Flight Procedures Cover Page	Task Action: FLIGHT CHECK	Task Type: IAP	Estimated Chart Date: 11/27/2025	APWS Task ID: 8454275F06A642C2AEF921671BBA5530	APWS Project ID: 9FCDF211ADE44E2586498C819B566D33
Procedure: ILS M RWY 31R ORIG		Enroute: NO	Specialist: Keefer, John		Agreement Number:
Airport ID: KMDW			Airport City: CHICAGO		State: IL
Facility ID: MDW	Facility Type: ILS	Flight Inspection Remark Type: New FC Slot			
<p>Procedure Comments:</p> <p>Redesignated Rwy 31C to Rwy 31R. Airport pending data used. Update Three Existing Waivers. Cancel Missed Approach Section 1b Waiver.</p> <p>WAIVER (1): Specify landing minimums below the minimum prescribed HAT of 250 due to "W" surface penetration. WAIVER (2): Specify visibility lower than the prescribed minimum of 3/4 SM/4000 RVR. WAIVER (3): Specify altitude restriction (hold down) in missed approach segment.</p> <p>WAIVER CANCELATION: Specify landing minimums below the minimum prescribed HAT of 250 due to Missed Approach Section 1b penetration.</p> <p>Contact Casimir Tabaka 405-954-7931.</p> <p>06/17/2025: THIS IS A CORRECTED COPY OF THE FORM APPROVED ON 05/23/2025. MISSED APPROACH INSTRUCTIONS: CORRECTED "IGECY INT/EON 19.5 DME" TO "IG

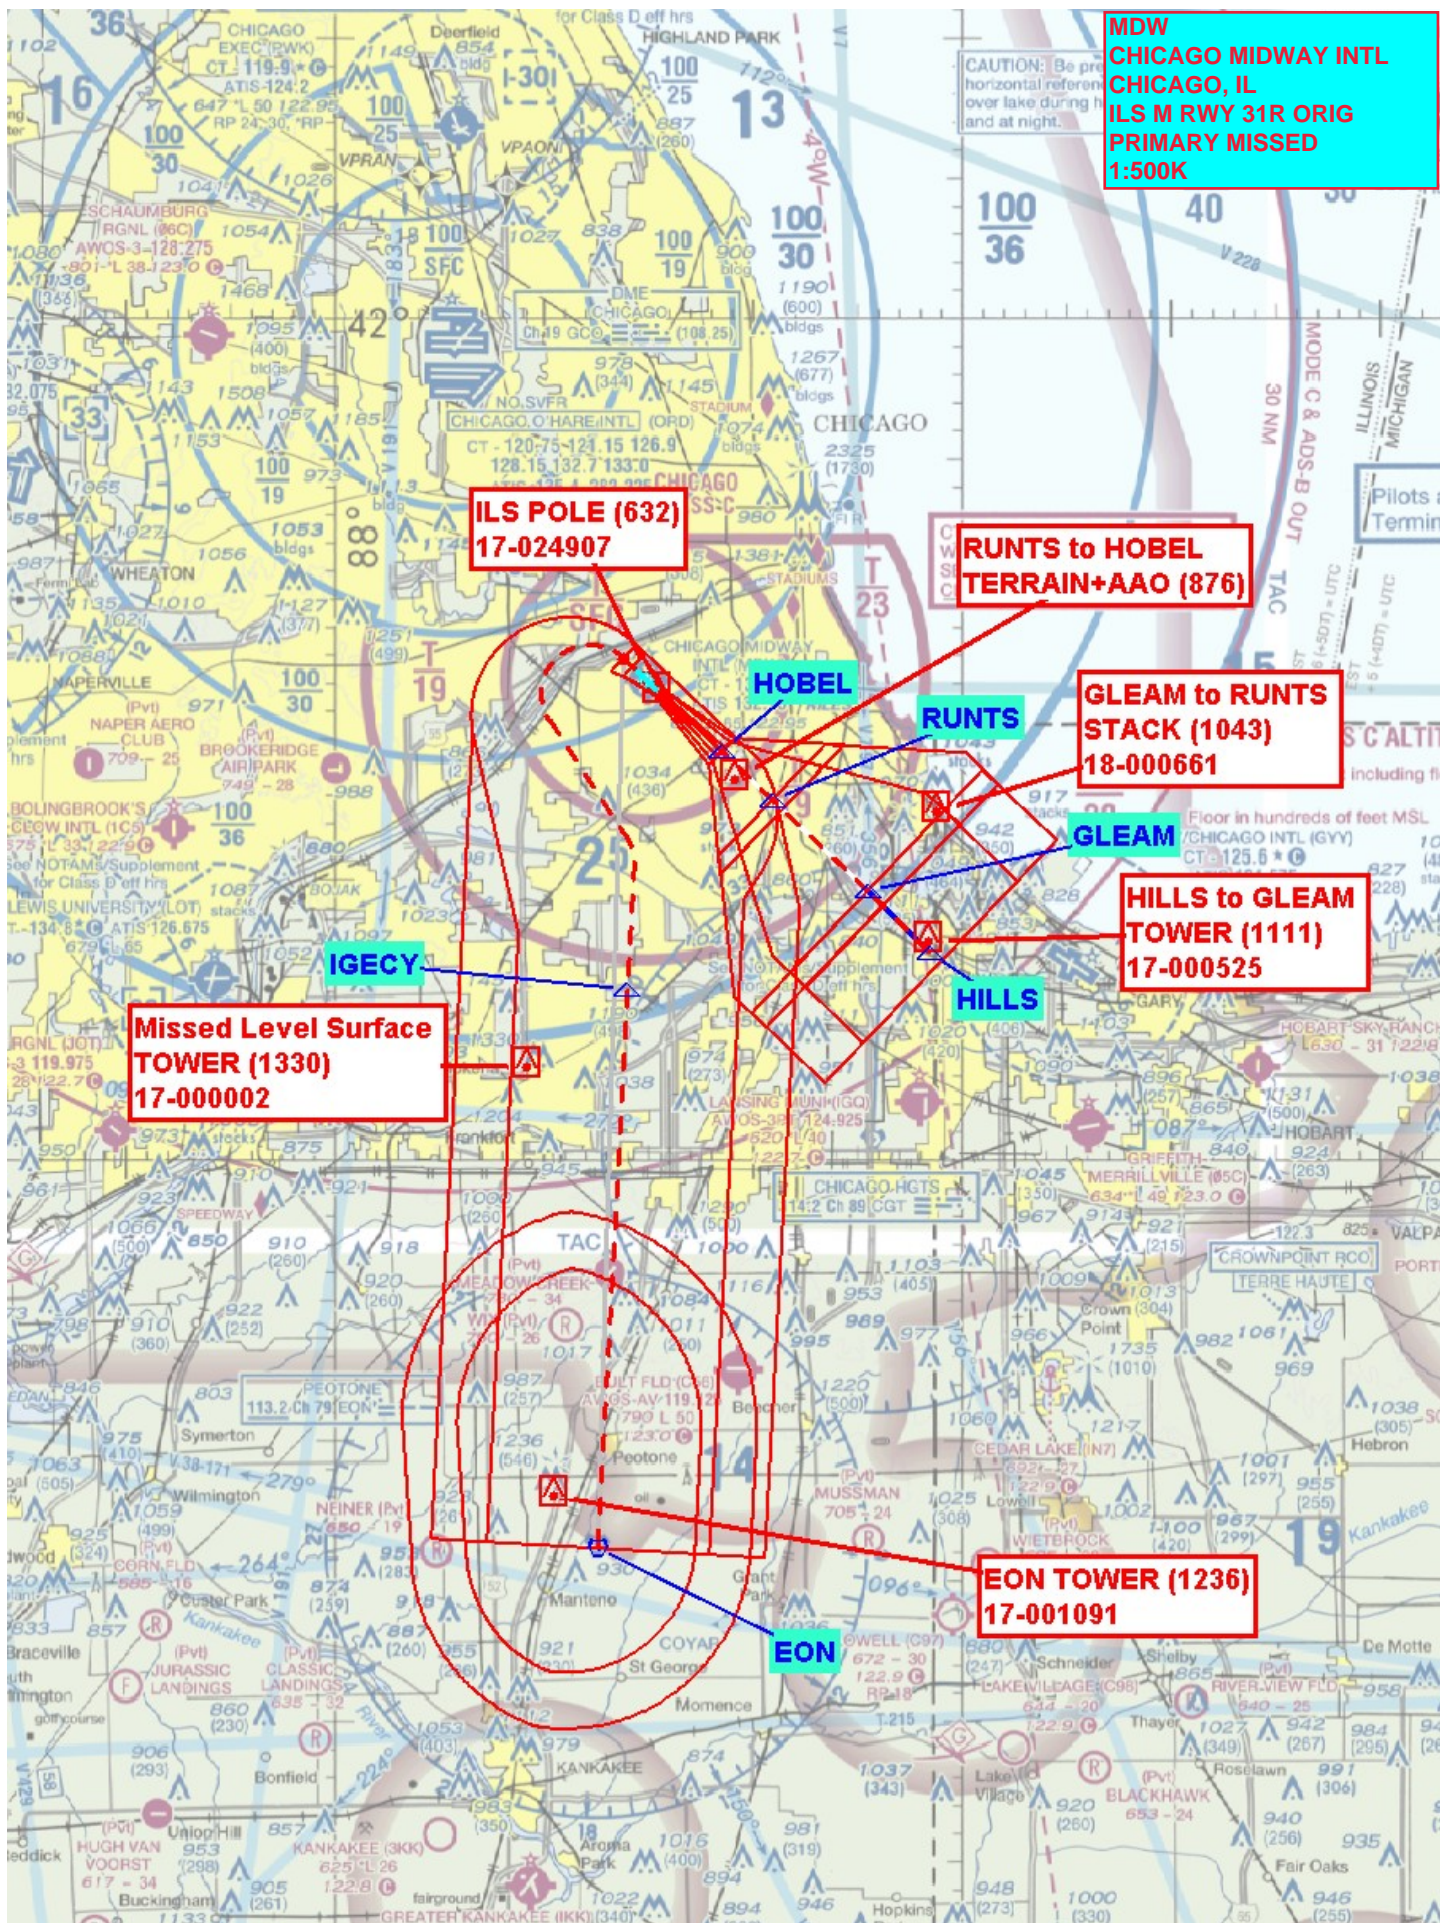
To specify landing minimums 204 HAT, lower then prescribed by FAAO 8260.3G 2-8-8. a, b.

Due to missed approach section 1b and 1c penetrations, the minimum HAT should be 250 feet. This waiver permits lower than standard landing minimums based on additional aircraft equipment and additional pilot training/proficiency. Results in fewer flight diversions or cancellations due to inclement weather.

This waiver is canceled effective November 27, 2025.

TARGETS indicates there is no Missed Approach Obstruction penetration with a 204 HAT.

**MDW  
CHICAGO MIDWAY INTL  
CHICAGO, IL  
ILS M RWY 31R ORIG  
PRIMARY MISSED  
1:100K**

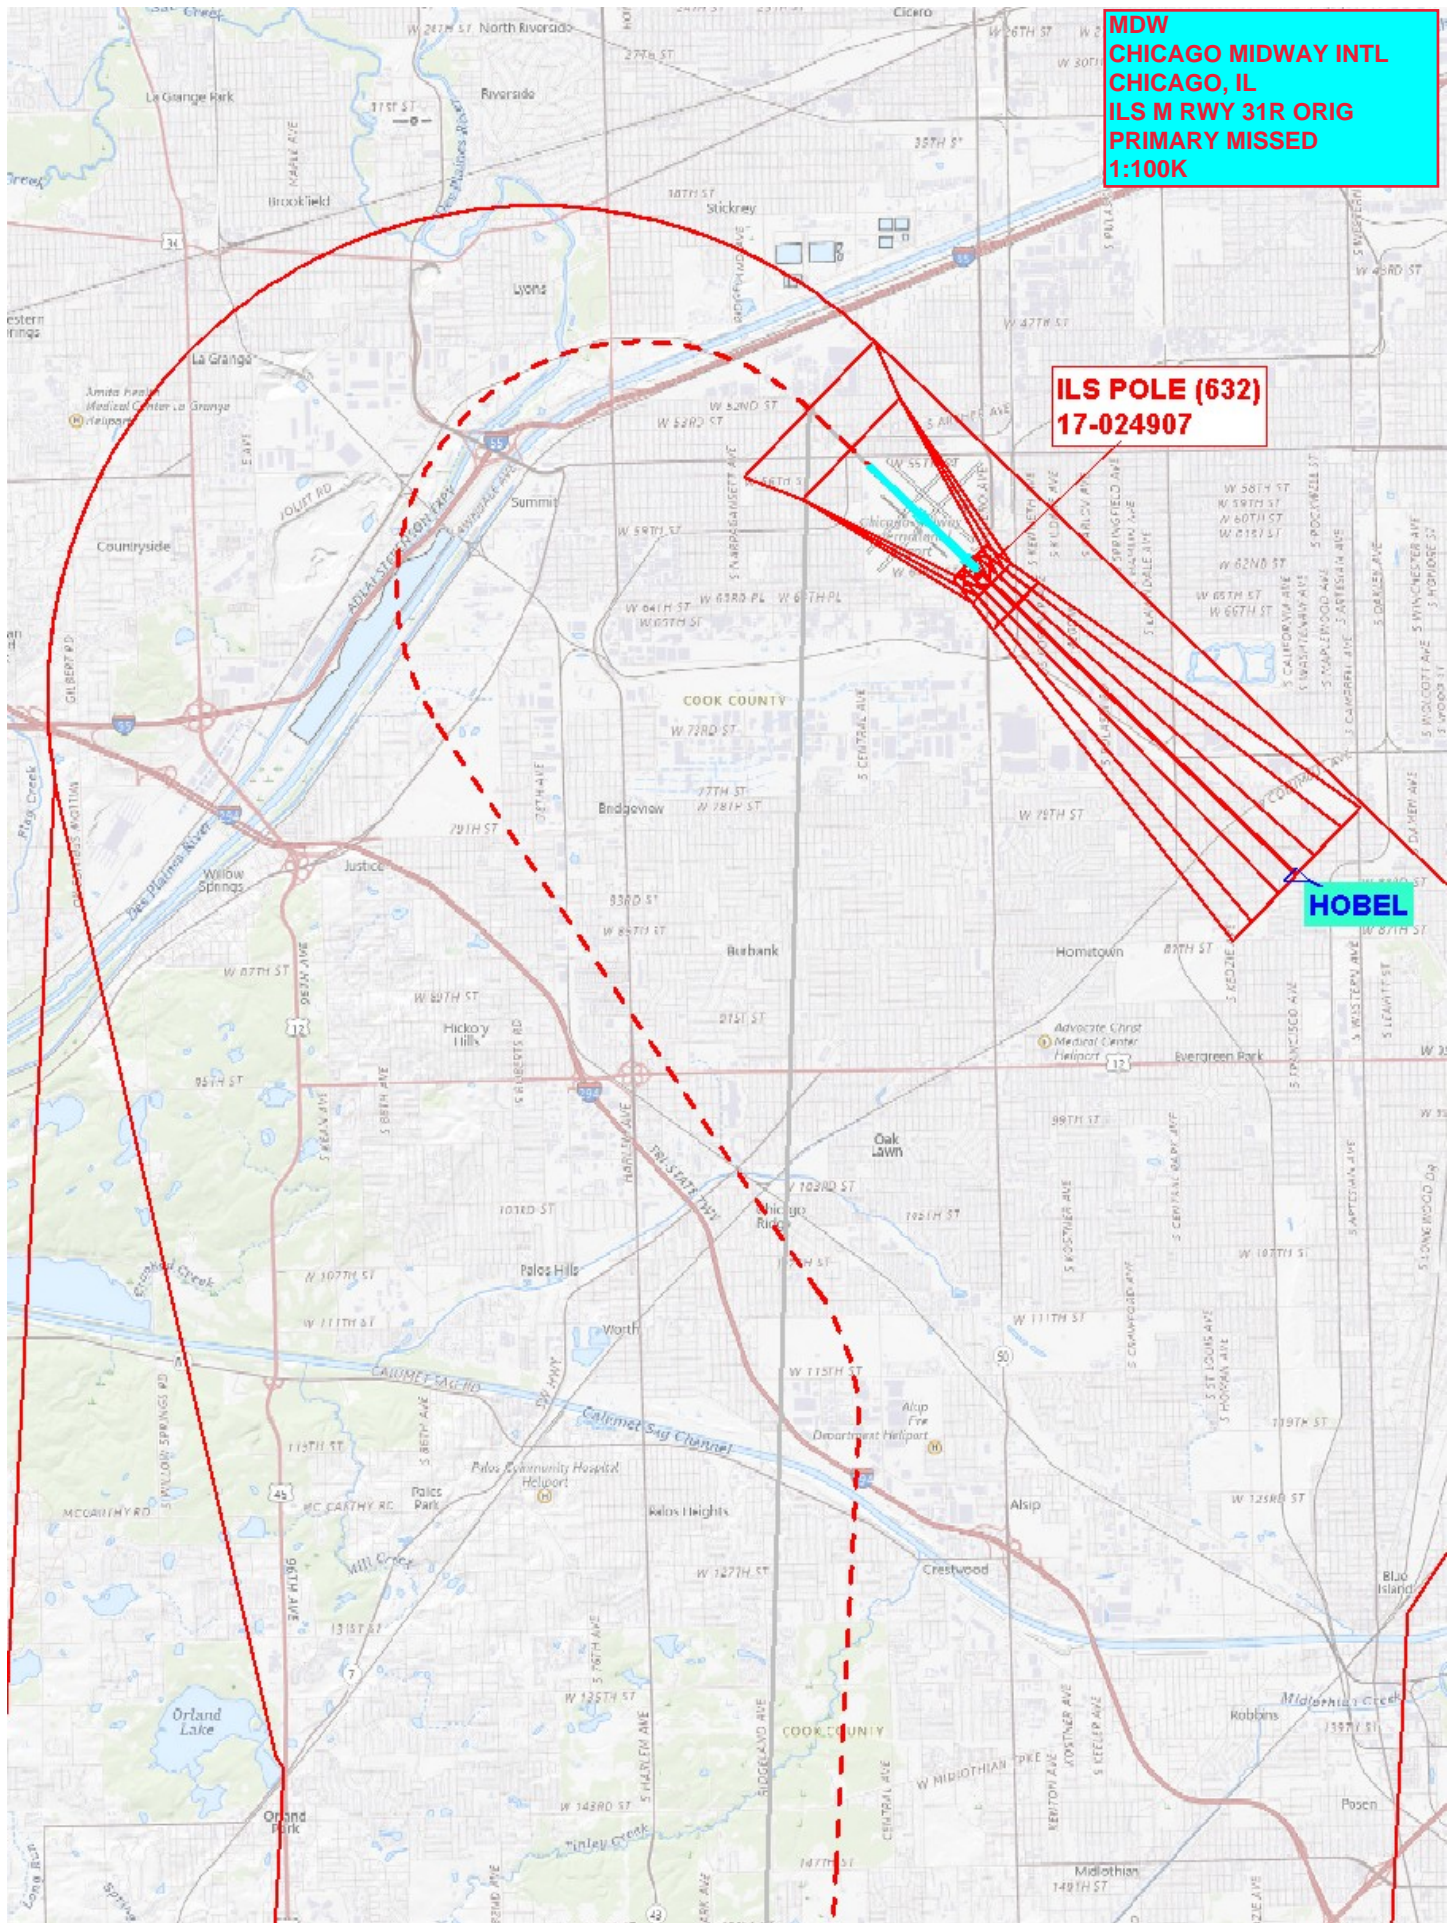
Waiver required to use an "at" altitude in the missed approach. Applicable Standard: FAAO 8260.3G, 2-8-8 c, 3, 4.

Air traffic has a need to keep aircraft that are executing a missed approach at 2100 ft until clear of overflight traffic.

40:1 OCS and level surface evaluations were evaluated from the DA/MAP to IGECY to the clearance limit. The "at" altitude of 2100 MSL provides 1000 feet of ROC for the aircraft that level off at 2100 MSL. From IGECY to the clearance limit the OCS was evaluated beginning at 1100 MSL (2100 MSL less 1000 feet of ROC) at IGECY to simulate the first level surface portion of the missed approach.
